Nords Wharf Concept Plan Modification 2

Amendments to the Awabakal Drive and Pacific Highway
intersection upgrade requirements

(MP 10_0088 MOD 2)

Subtitle: Section 75W Modification Assessment

A comparison of a seagull signalised intersection and full signalised intersection is provided at **Figures 3 and 4.**

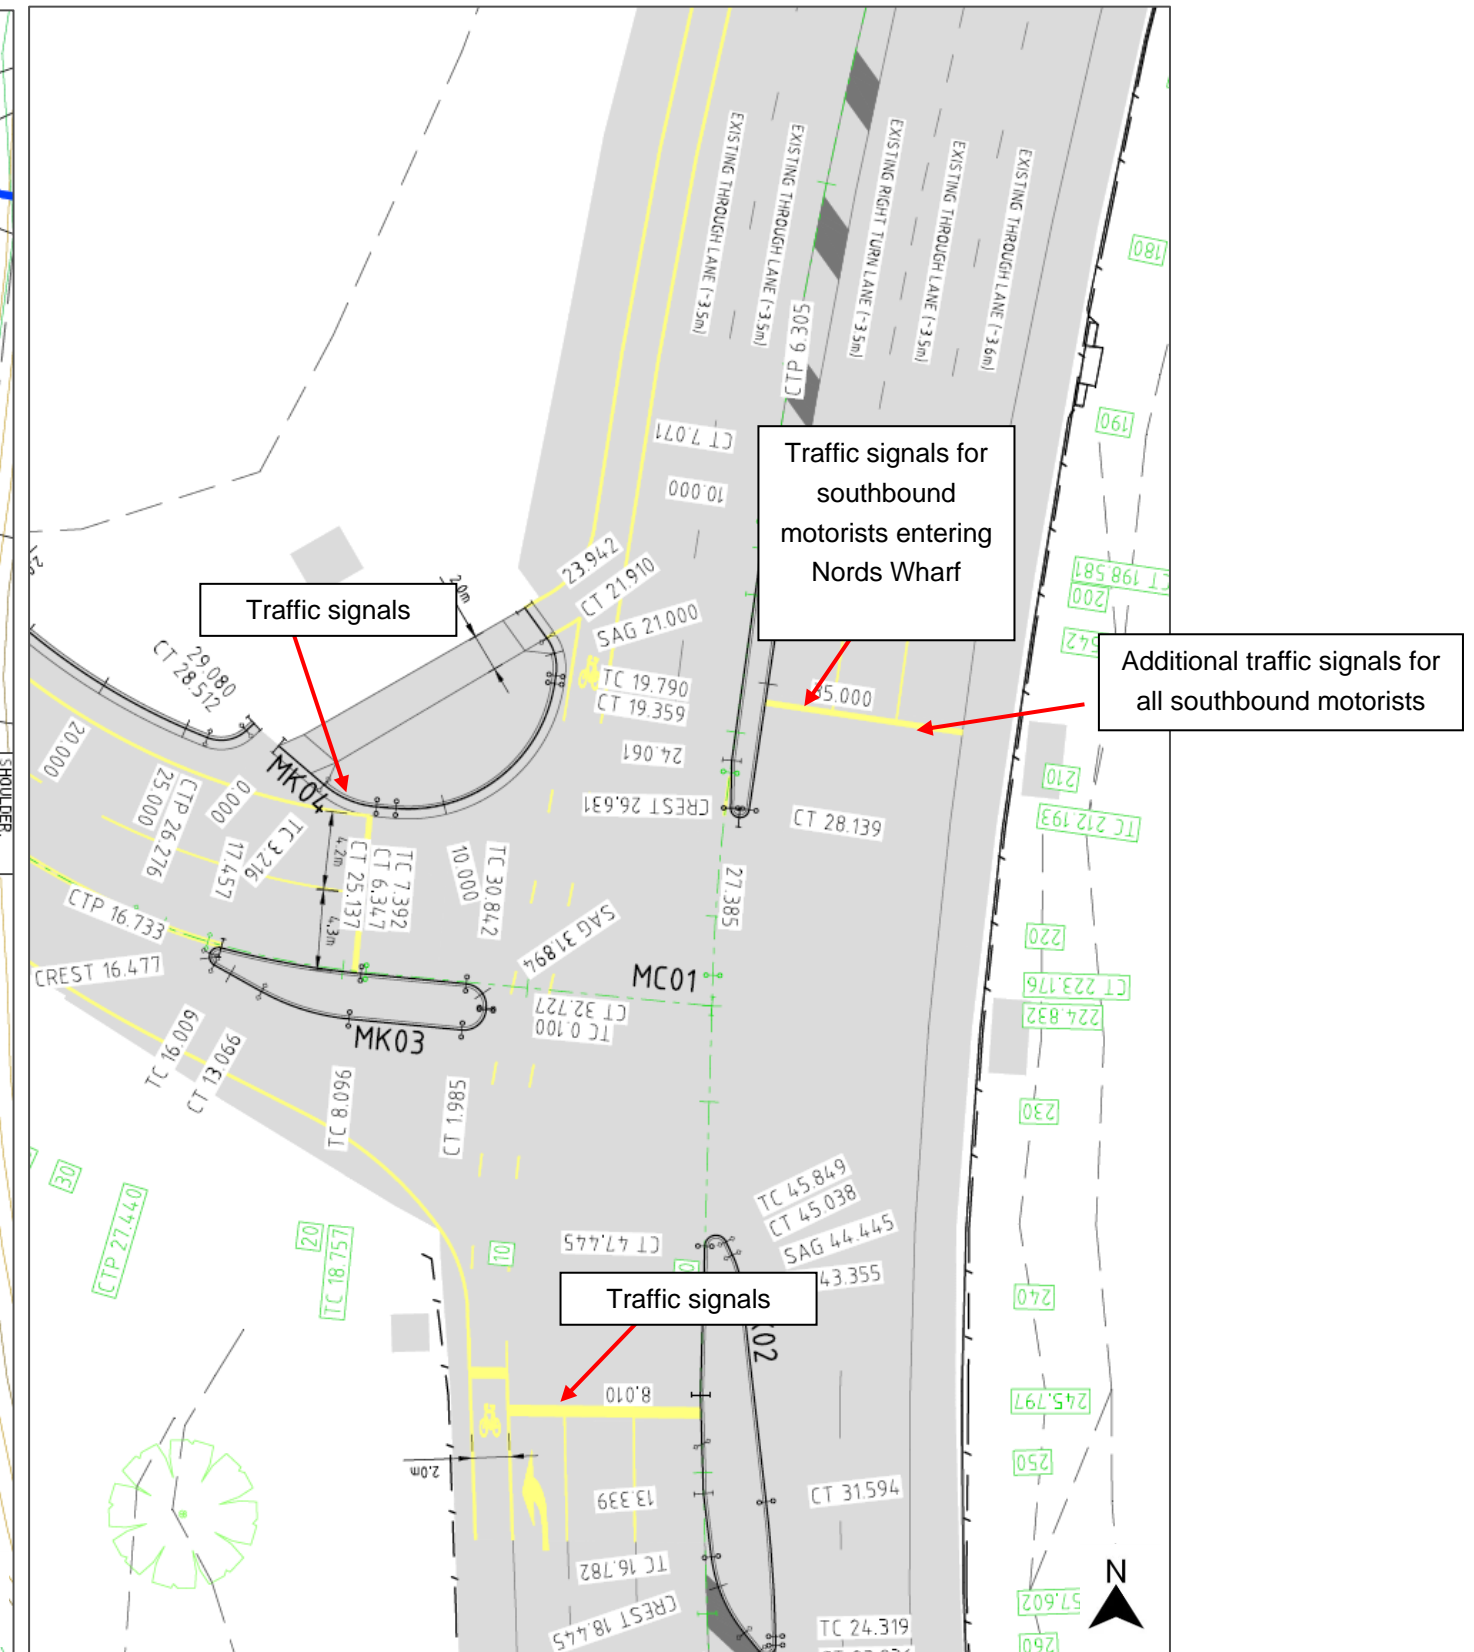
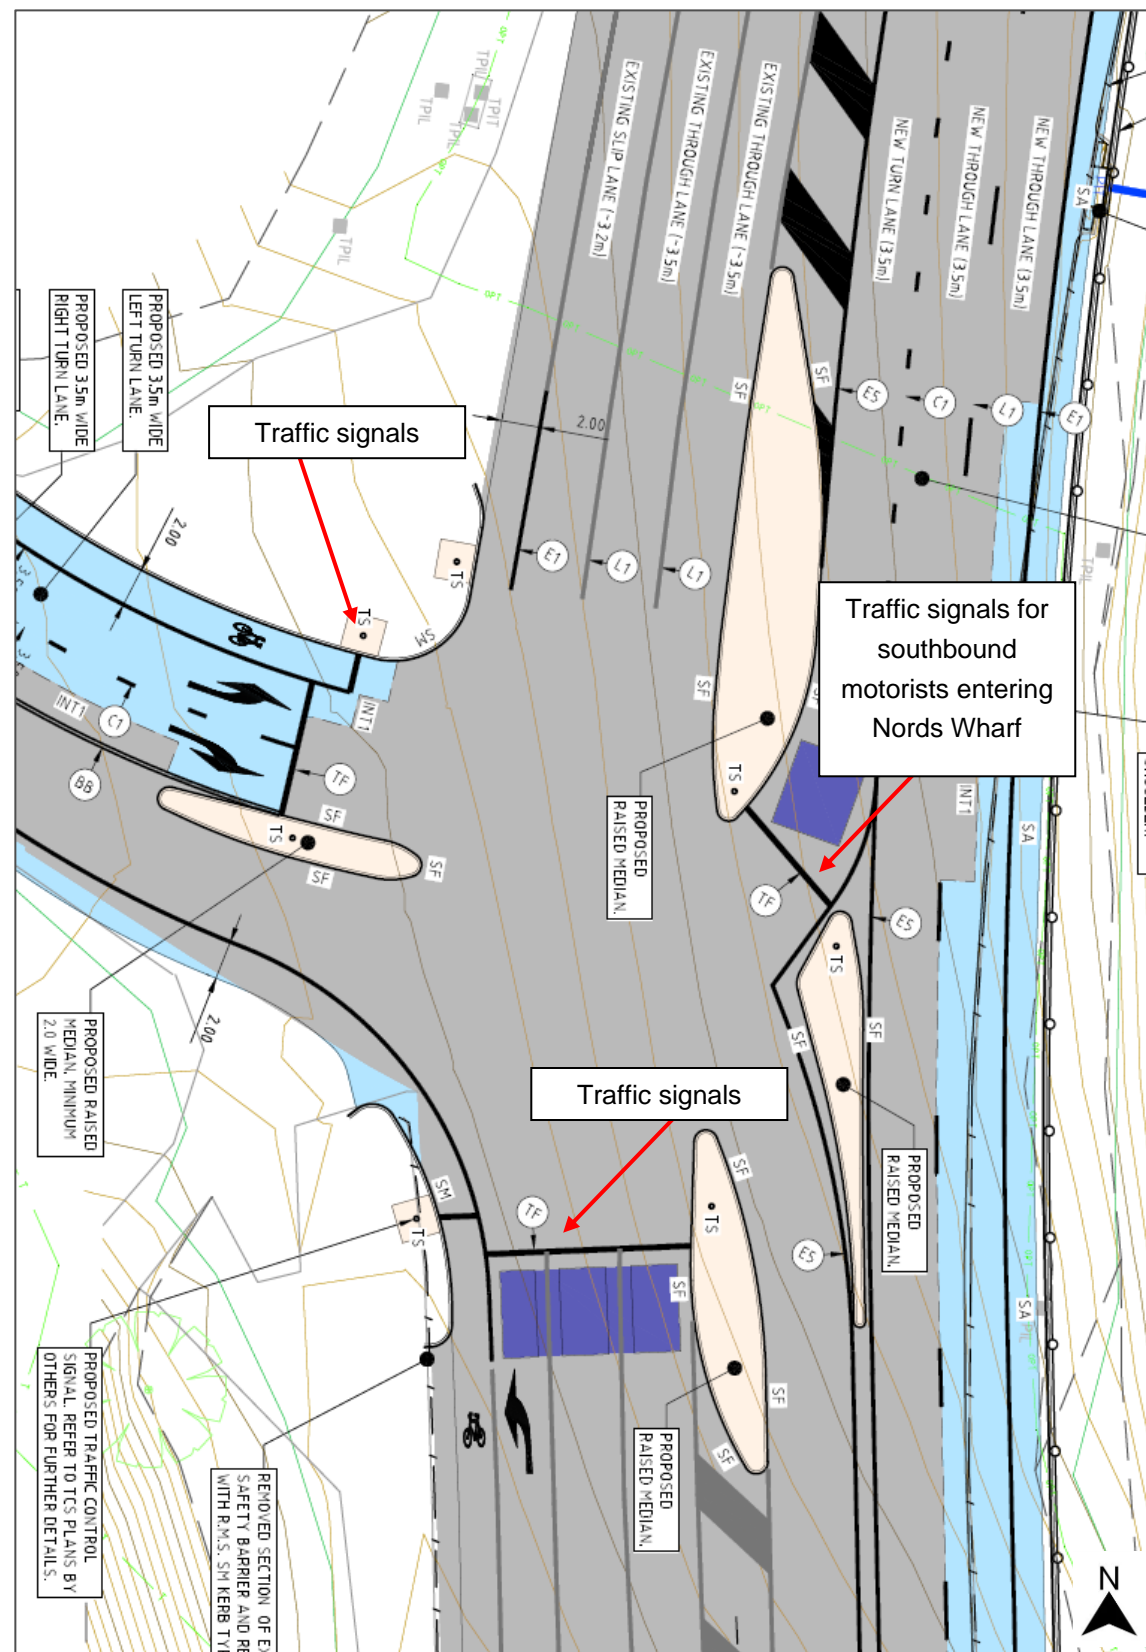
The request seeks to amend FEAR 1.25 to require the Awabakal Drive and Pacific Highway intersection to be upgraded from a signalised seagull to a full traffic control signal in accordance with current Transport for NSW (TfNSW) requirements. The proposed amended FEAR 1.25, as recommended by TfNSW, is outlined below.

The proposed modification is sought on the basis that TfNSW (formerly RMS) no longer supports the installation of signalised seagull intersection at this site, and requires full signalisation to address safety requirements.

As demonstrated in **Figures 3 and 4**, the main change associated with the full signalisation is the addition of traffic lights along the Pacific Highway for motorists travelling south, allowing motorists to exit Nords Wharf without having to merge into oncoming traffic. It is noted that traffic signals were already proposed as part of the signalised seagull intersection design for motorists travelling south and turning right into Nords Wharf. Therefore the Department considers the proposal is unlikely to result in additional traffic on local roads within Nords Wharf, and the main impact is likely to be additional stopping along the Pacific Highway.

- 1.25 *The detailed design for the upgrade of the Pacific Highway / Awabakal Drive intersection must be prepared in accordance with RMS's requirements intersection (outlined in the advice provided to the Department, Reference: 252DA144:1, dated 16 December 2010 and as amended by Condition 1.25A) **to the satisfaction of TfNSW requirements to a full signalised intersection.** In designing the upgrade, the Proponent should consider opportunities to provide a pedestrian phase in consultation with council and the RMS **TfNSW.***
